DOMINION ENERGY KEWAUNEE, INC.
KEWAUNEE POWER STATION
LICENSE RENEWAL APPLICATION
SECOND ANNUAL UPDATE REQUIRED BY 10 CFR 54.21(b)

SUBSTATION/SWITCHYARD MODIFICATIONS

ANNOTATED PAGES FROM KPS LRA

Figure 2.1-2 Offsite Power for SBO

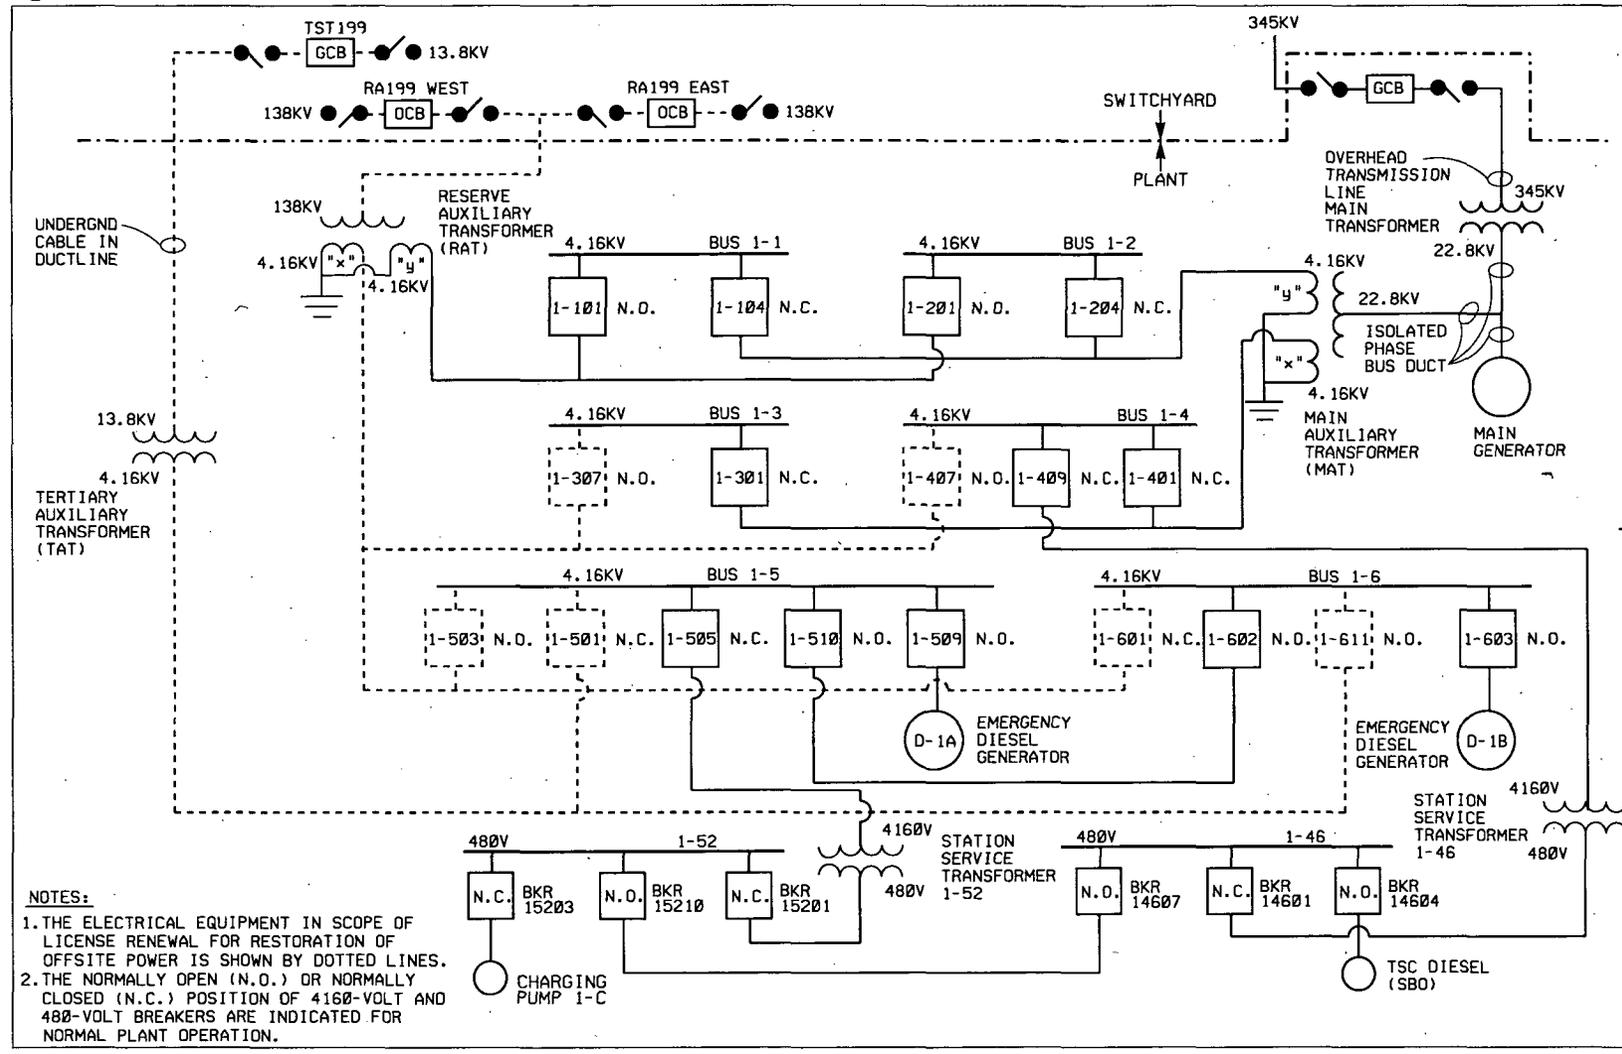
The substation/switchyard upgrade reconfigured the 138 kV switchyard bus, installed new 138 kV breakers, installed a new 138 kV/13.8 kV Tertiary Auxiliary Transformer (TAT) Supply Transformer (TST), a new 13.8 kV SF6 Gas Circuit Breaker (TST 199) and associated disconnect switches, and associated control cables and connections. A new 13.8 kV feed from the TST transformer secondary disconnects was spliced to the existing 13.8 kV underground feeder cable to the in-scope TAT at an underground pulling pit, which was expanded above ground and a cover was installed to protect the cable splice. The TAT was replaced with a higher capacity transformer to provide for future additional capacity for the TAT circuit to the 4160V buses. The new switchyard 138 kV connections to this circuit allow multiple possible 138 KV switchyard feeds for this circuit for increased reliability.

NOTE: This Figure has been replaced in it's entirety.
